RE: Amendment Application for the Hotazel Solar Facility

ABO Wind Hotazel PV (Pty) Ltd wishes to apply for an amendment to the authorised Hotazel Solar facility (EIA Ref No: 14/12/16/3/3/2/1086), located near Hotazel in the Northern Cape. The Environmental Authorisation (EA) Amendment Application proposes a change to the layout of the facility. Cape EAPrac has therefore requested a comparative assessment and comments from 3Foxes Biodiversity Solutions to assess the proposed changes in the context of the former Ecological Impact Assessment and to determine any impacts resulting from the proposed amendments. The motivation for and nature of the intended amendment include the following:

Figure 2. Ecological sensitivity map of the study area, showing the approved and the proposed amended footprint of the PV field.

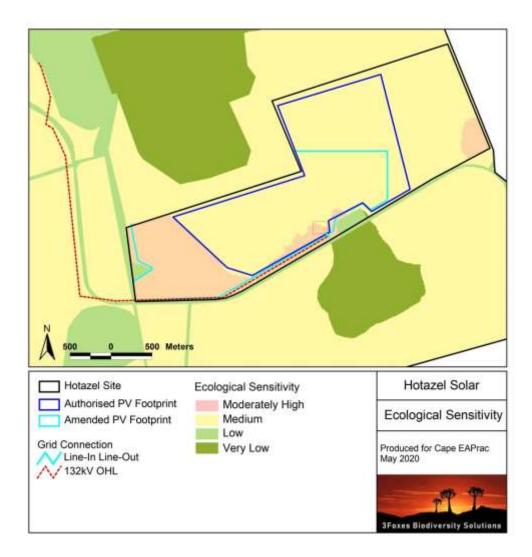
The approved and the proposed amended PV footprint areas in relation to the ecological sensitivity of the site, are illustrated below in Figure 2. The shift of the PV field to the west of the site will result in an increase in areas classified as "Moderately Sensitive" falling within the new development footprint. The newly affected area is largely similar to the areas within the existing footprint, but has a higher density of protected trees, mostly *Vachellia erioloba* and *Vachellia haematoxylon*. The density of *V.haematoxylon* within the proposed new footprint area is approximately 30 trees per hectare, which is higher than the average density within the current development footprint. As a result, the total number of protected trees within the development footprint is likely to increase by approximately 1000 trees. This is not considered

to represent a significant loss to the local population of either *V.erioloba* or *V.haematoxylon* as the density and number of these trees in the local area is very high and probably numbers in the millions. The original assessment found that "Although relatively large numbers of *Acacia haematoxylon* (2000-6000) would potentially be lost as a result of the development, the extent of habitat loss (275 ha) is not seen as being highly significant for this species and is of local relevance only and as such, is not seen as sufficient to warrant an offset or other similar off-site mitigation measure." The increase in the number of affected trees is approximately 15% and this is not considered to represent a significant increase that would invalidate the original findings of the EIA. As such, the original conclusion of that study as quoted above is considered to be consistent with the amended layout.

Overall, the amended layout would increase the impacts of the development on protected trees. However, the increase is not considered sufficient to increase the original post-mitigation significance from Medium to High. As such, the original Medium negative post-mitigation impact on vegetation and protected tree species would remain unchanged.
